REMARKS

This application has been carefully reviewed in view of the Office action mailed April 17, 2002. Claims 1, 2, 8, 10, 17, 19-21, 26 and 29-31 have been amended. Claim 32 has been cancelled. Figures 2, 3 and 4 have been amended. Furthermore, paragraphs on pages 1, 8 and 9 of the Specification have been amended. Reconsideration and favorable action in this application is respectfully requested.

FIG. 3

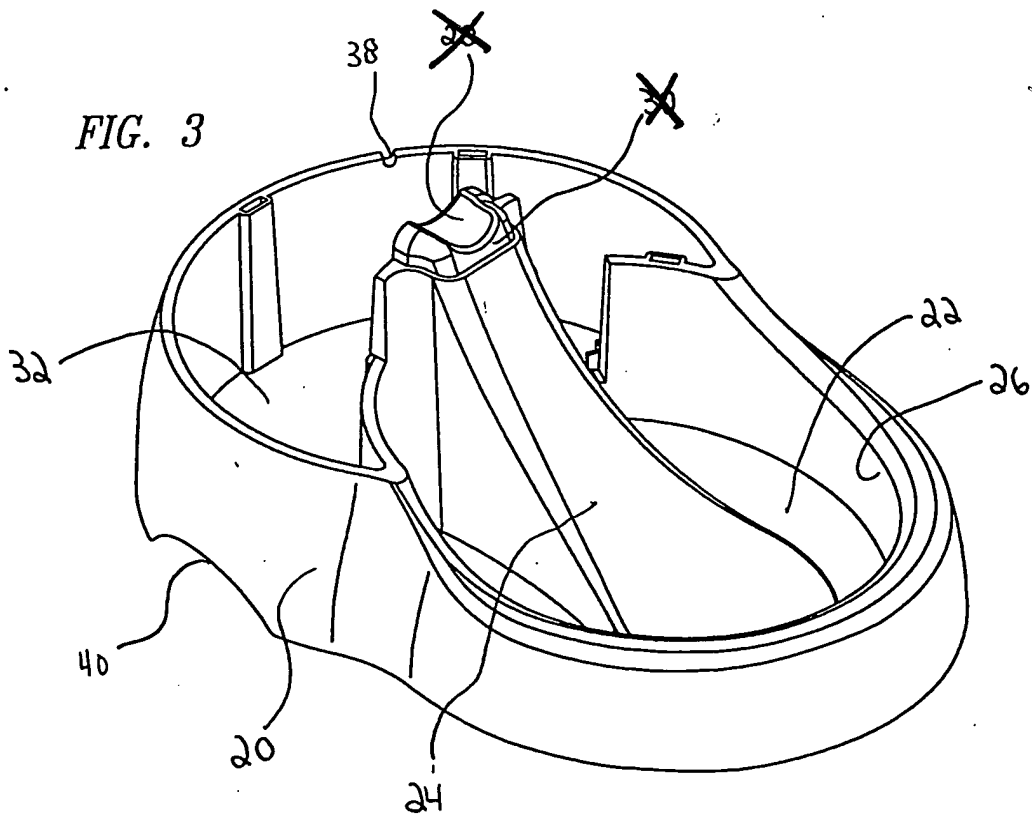
The Examiner has objected to the drawings as failing to comply with 37 CFR 1.84(p)(4) because reference characters "28" and "30" have been used to designate parts on both items 20 and 42. Applicant has corrected the drawings by deleting reference characters 28 and 30 on item 20. A marked up copy of Figures 2, 3 and 4 is attached hereto together with a clean copy of Figures 2, 3 and 4. Examiner approval of these drawing corrections is respectfully requested.

FIG. 2

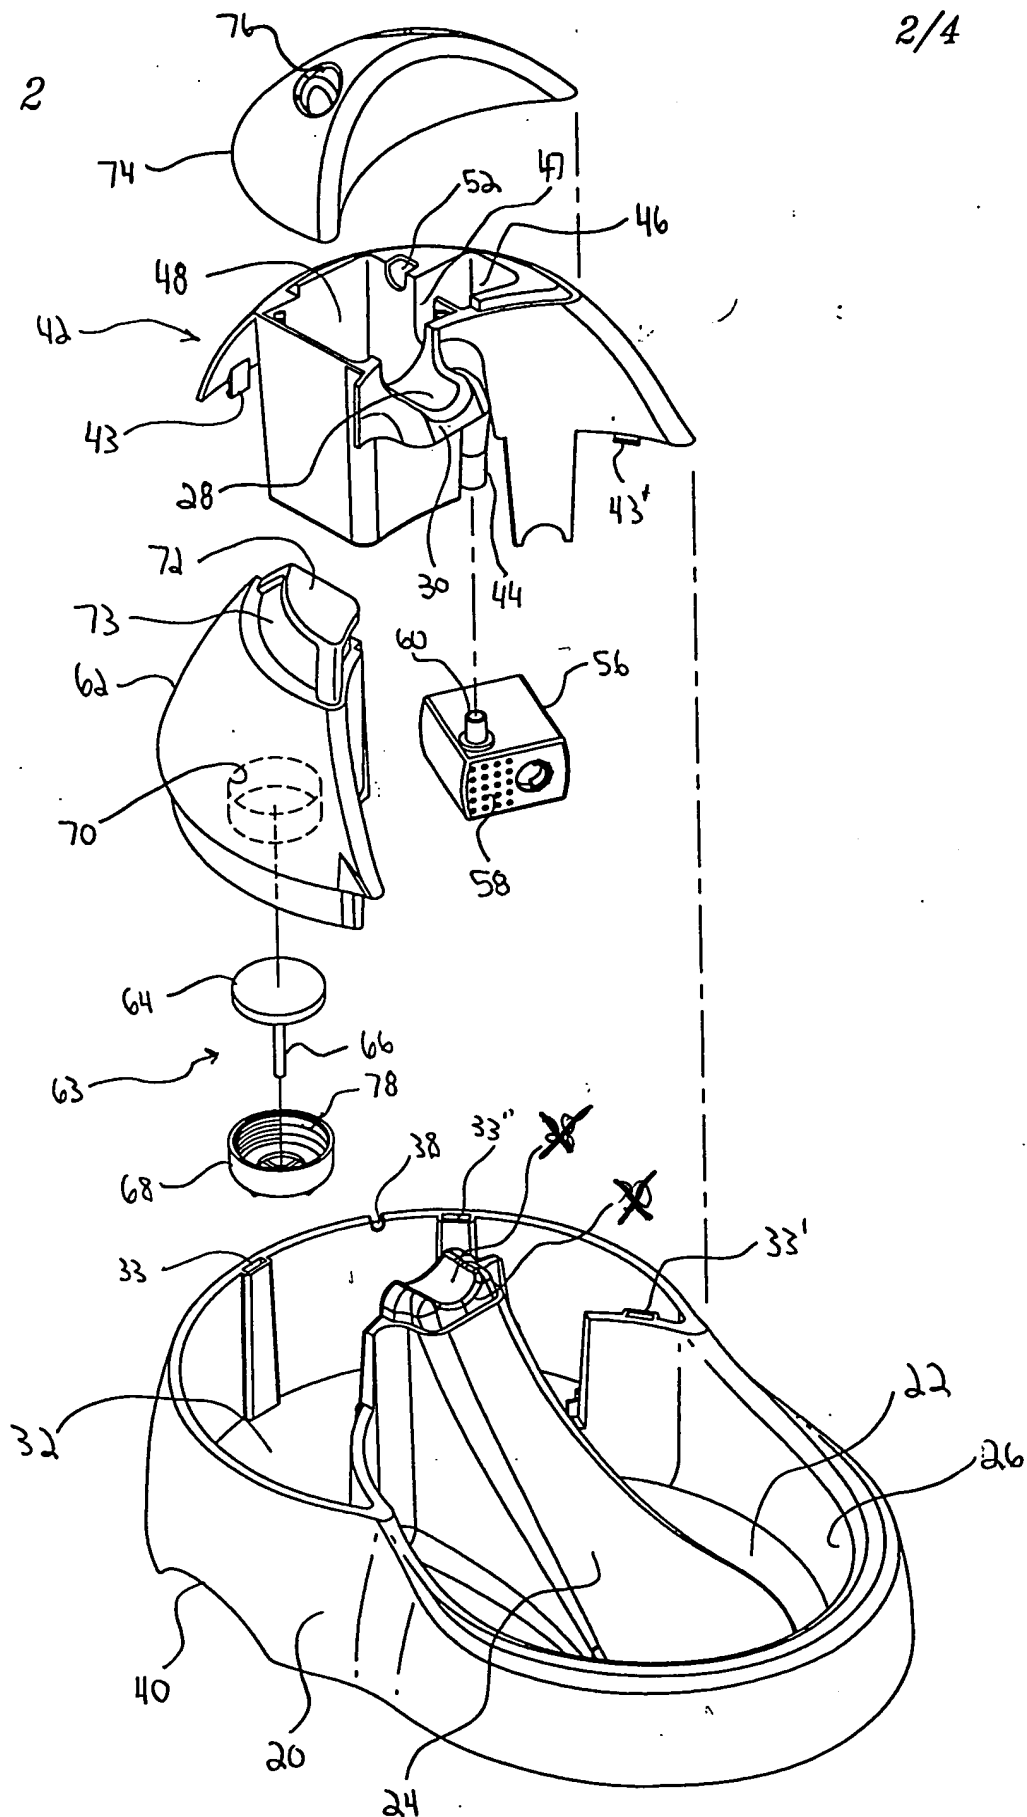
Further, the Examiner has objected to the drawings as failing to comply with 37 CFR 1.84(p)(5) because reference signs 72 and 74 are not mentioned in the description. Applicant has added the reference sign "72" on page 9, first full paragraph in line 11 after the word "surface" to denote a "flat storage surface 72." With respect to reference sign 74, Applicant directs the Examiner to page 9 at the third full paragraph. Reference sign 74 can be seen in the first sentence of this paragraph denoting a "lid 74."
